Re: Pre-Development Application advice request. Proposed Residential Flat Building (Affordable Housing) 56 Beane Street, Gosford

I refer to your email of 10 September 2019. The following comments are provided on the proposed development.

Figure 1- Water, sewer, drainage and easement plan

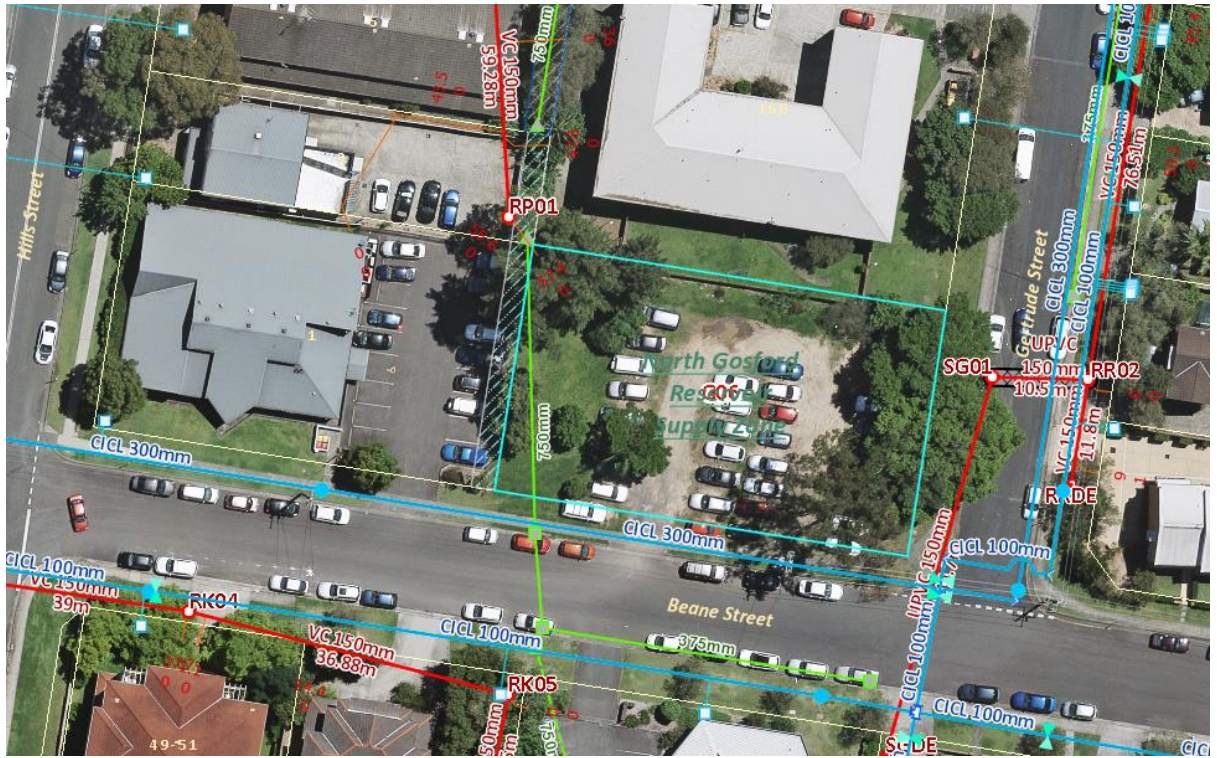
- The development will need to comply with section 6.7.10 of Council's Gosford DCP213 in relation to structures adjacent to a Council stormwater pipeline / easement. Structures are not permitted over the pipeline and suitable clearance to the pipeline would be required to comply with a 3m wide easement to drainage centrally located over the pipeline alignment.
